**Papanui PAK'nSAVE Integrated Transport
Assessment**

Foodstuffs South Island Ltd

Appendix D
Road Safety Audit and Responses

Main North Road Pak and Save traffic signals

Figure 1: Lydia Street Roundabout proposal.

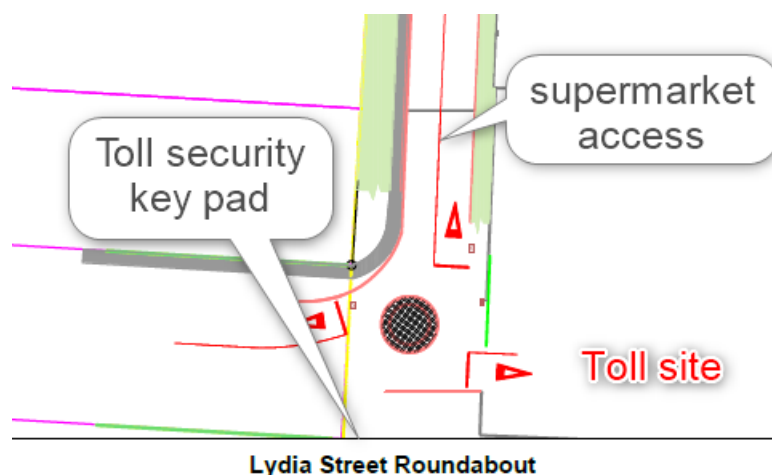
The plans show a roundabout is proposed at the Lydia Street access to the site shown below.

The team do not consider this to be a feasible option given the current users of the intersection and its layout. B trains were seen on the Toll site and they had come through the intersection. This is the only access to the Toll site. Similarly, there was a small industrial site to the west of the intersection.

Figure 2: Pedestrian path through the carpark.

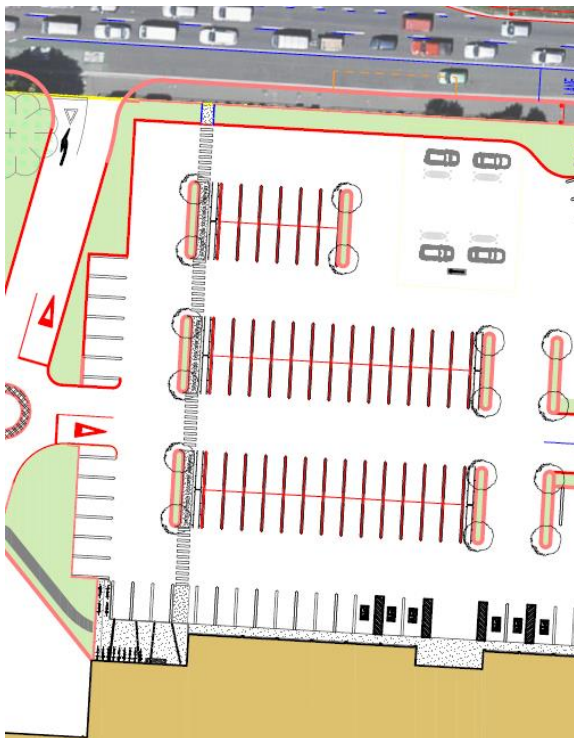
A pedestrian access route from Main North Road to the supermarket is shown on the plans in the extract below. The team is unclear where the main pedestrian access to the supermarket is proposed to be but it would appear to be further south than where the pedestrians will be deposited. It is also unclear if there is a pedestrian path along the front (eastern side) of the supermarket, and whether the two bicycle parking areas will be covered.

The SAT consider that a better location for the pedestrian route through the site to access the supermarket would be near the traffic signals where a safe crossing point can be constructed across Main North Road. Other internal pedestrian paths from the carparking spaces to the supermarket main access should be developed.

Figure 4: Internal roundabout with limited queueing.

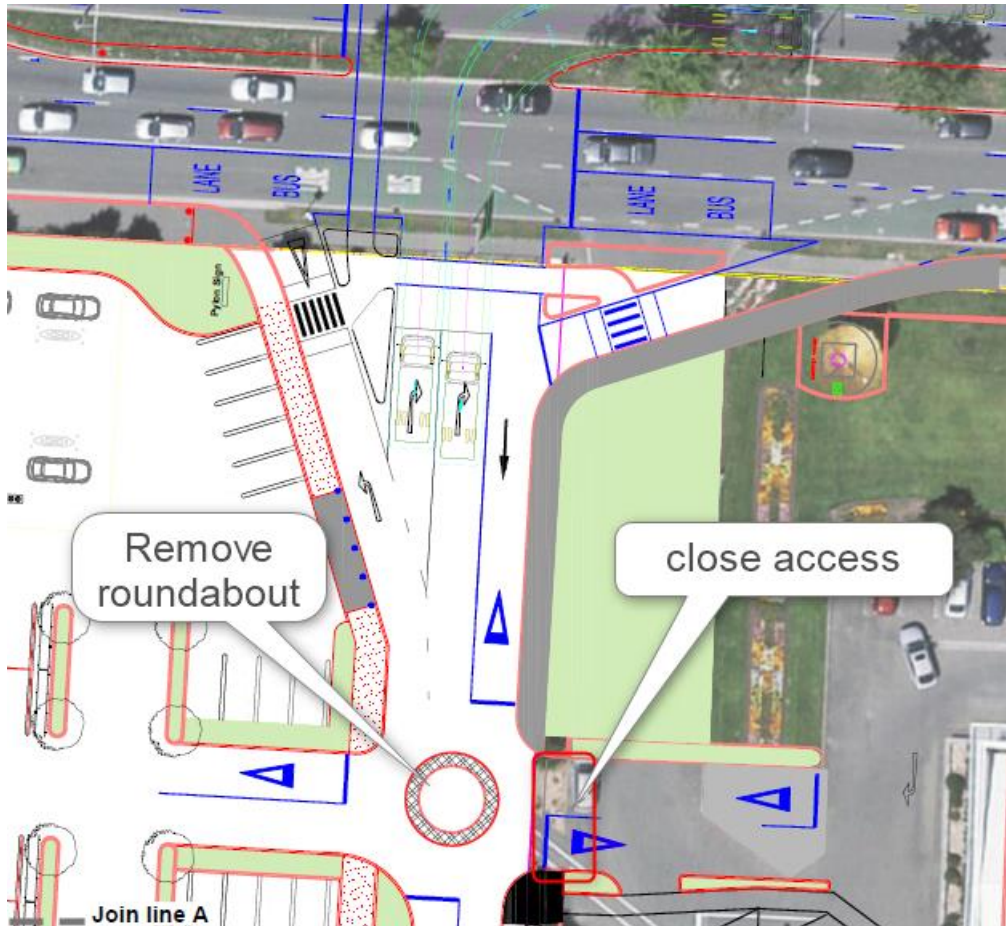
The SAT considers that the roundabout should not be constructed and the staff carpark to the south not have access to the traffic signals but use the new high standard uncontrolled access beside number 161 Main North Road. This would be no different to the existing situation.

To prevent staff from performing U turns at the proposed traffic signals, a U turn facility could potentially be incorporated into the median south of the traffic signals.
